Appalachian Trail Conservancy

Re: In response to letter ATC received from LIVIC Civil on February 2, 2026 from Justin Ross at LIVIC Civil in response to ATC's January 9th letter of concern sent to Middlesex township.

Scenic, Historic and Cultural Concerns

Appendix A.

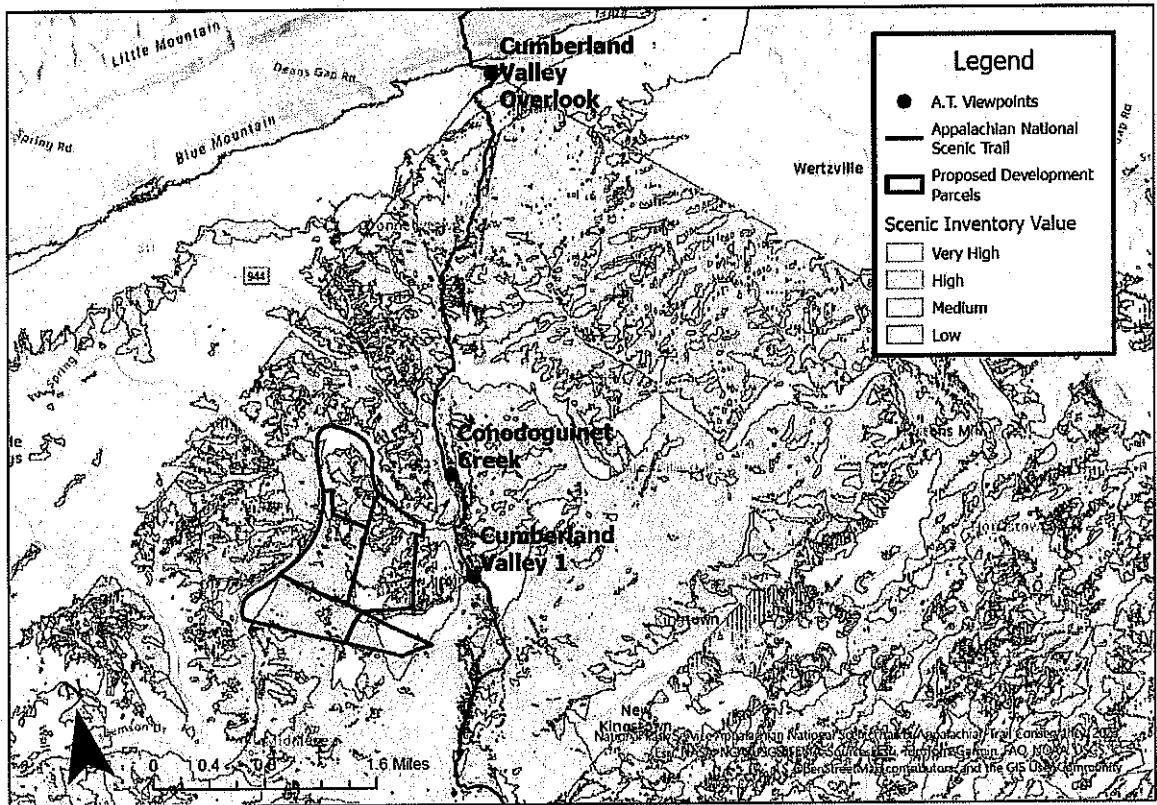
3. The photo of the view you shared is not substantially different from our own (Appendix A). However, the view cone which was drawn does differ significantly from the viewshed map we created (Appendix B) using the point and bearings that were collected as a part of our Visual Resource Inventory in 2021. We are also sharing the view from that spot during leaf-off, when there would be the most visual impact (Appendix C) to trail users.
4. Your analysis does not include the closest viewpoint from which the development would be visible, a viewpoint from the valley less than 0.3 miles away. Not only will the development be apparent from this viewpoint, Cumberland Valley 1, but will be visible for approximately 3000-ft stretch, or, an 8-minute walk, along the A.T. in a northward direction, which will adversely affect the viewshed that trail visitors will experience in this section.
